Village of Mukwonago
REGULAR PLAN COMMISSION MEETING
Notice of Meeting and Agenda
Tuesday, September 10, 2019

Subject: Phantom Lakes Preserve / **Conditional Use and PUD request and subsequent Site Plan Request**

Meeting: September 10, 2019 Plan Commission meeting (Decision Tabled from Aug. 13 Plan Comm.)

This letter is in response to the outstanding civil engineering plan comments in the review letter dated 7/31/2019.

Current zoning A-1 (Agricultural) and accompanying environmental features (floodplain hazard areas)

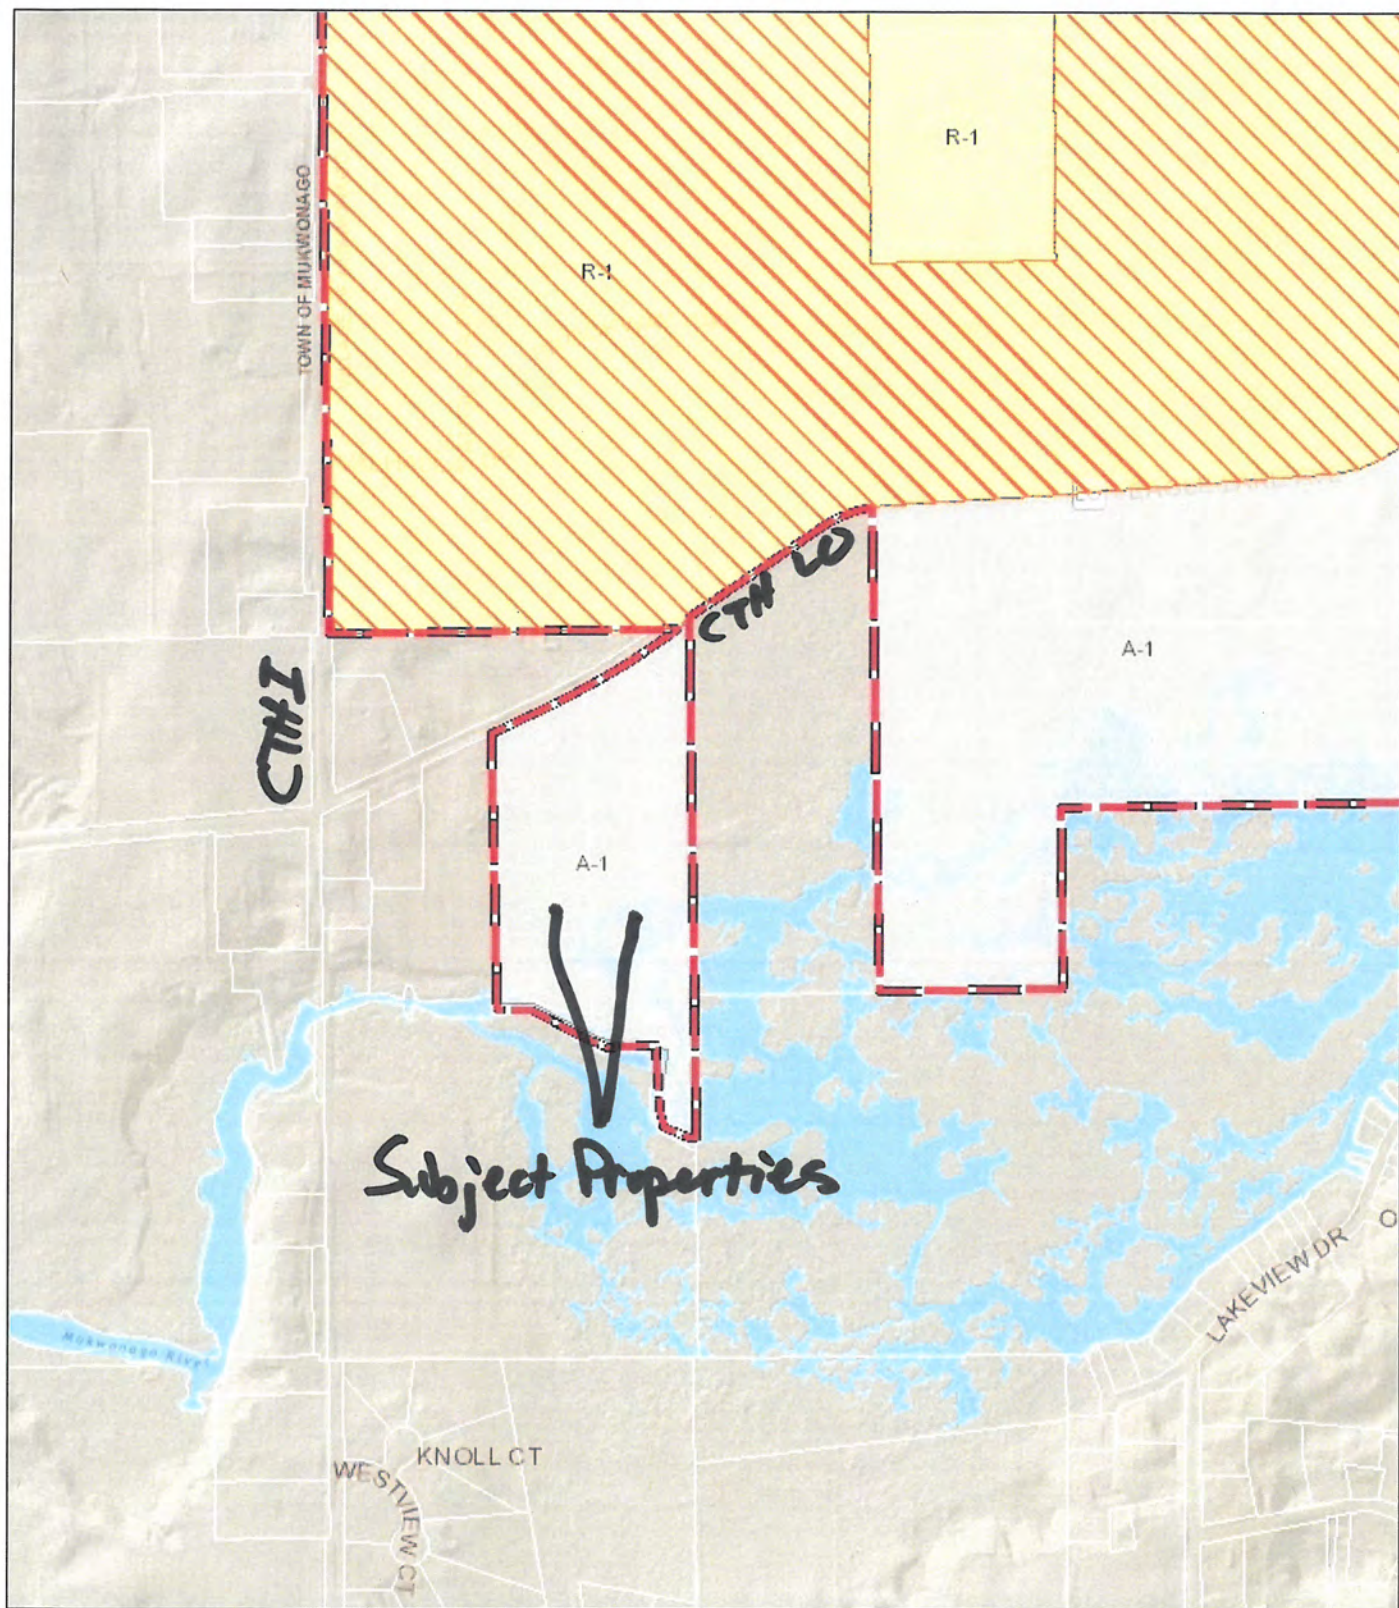
Staff Recommendation Approval for the R-5 rezoning. The proposal meets with the Comprehensive Land use Plan, which calls for Medium Lot Single Family (25,000 s.f.) and the R-5 density requirements are met. Staff also finds the proposal is appropriate in that the public utilities (water/sewer) services are available and can be accomplished, with all costs borne by the developer.

SHEET
C-6
OF
TBD

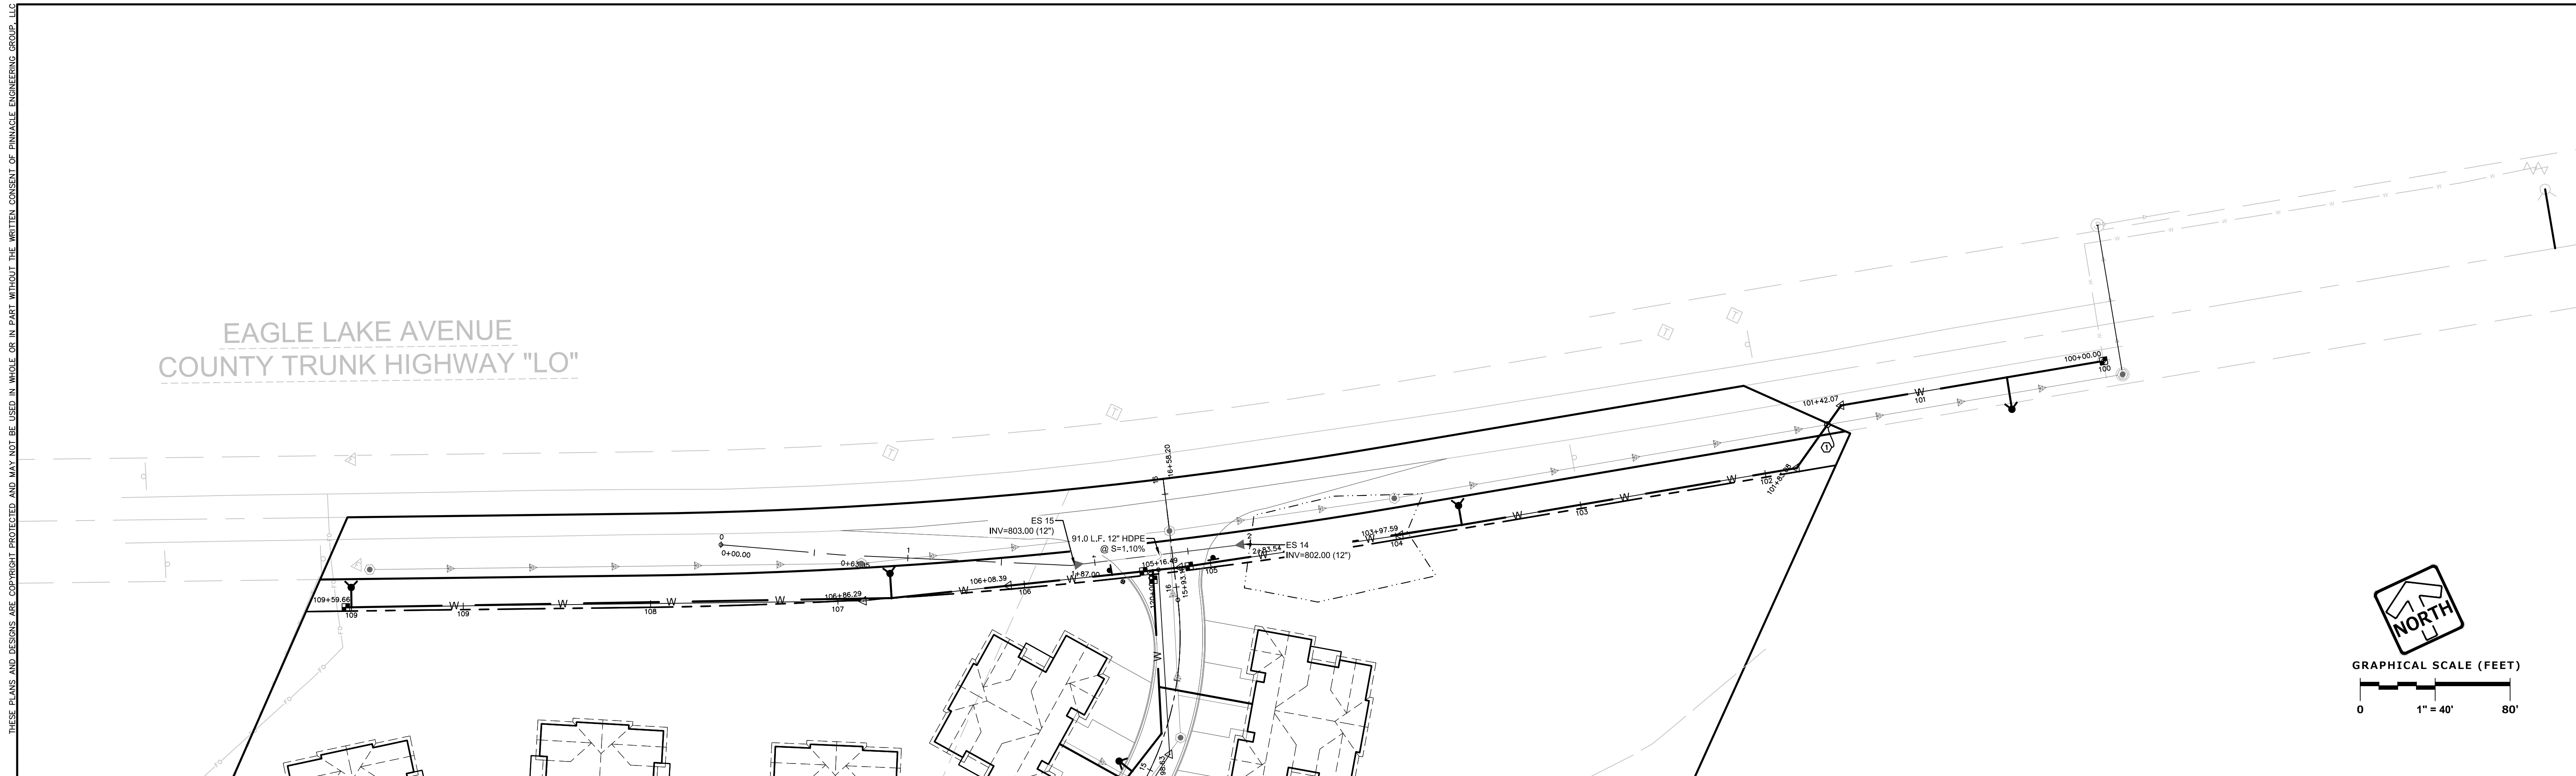
2. Water main and Hydrant Concerns; On the C-6 & C-7 Utilities Plan Sheets:
 - a. 8" watermain on CTH-LO not 16"
➤ The watermain on CTH-LO has been changed from 16" to 8"

- b. Add 4 main valves as shown locations on Sheet C-6 (attached to email).
➤ 4 main valves has been added as shown in attached mark-ups.
 - c. Hydrant spacing must not exceed 350' including public and private mains. (Two family units are classified the same as single family units in development code per building inspector review of codes.)
➤ Hydrant spacing has been adjusted so that the spacing does not exceed 350'.
